Model: CDP-X779ES

No. 288

Subject: Balanced Outputs in Reverse Phase

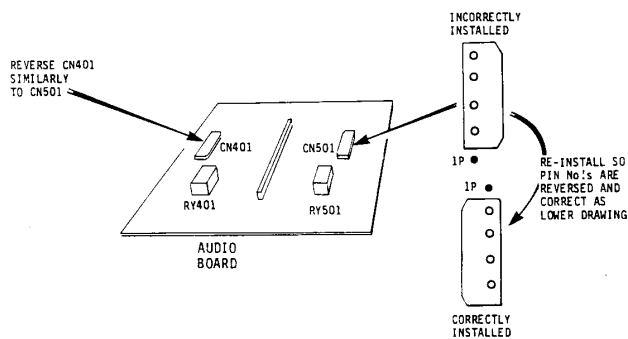
The phase on the balanced outputs is in reverse due to incorrectly installed connectors. CN501 and CN401 on the audio board have been mounted in reverse.

Remove CN501 (RED) and CN401 (BEIGE) from the audio board and install them in reverse order (see drawing below):
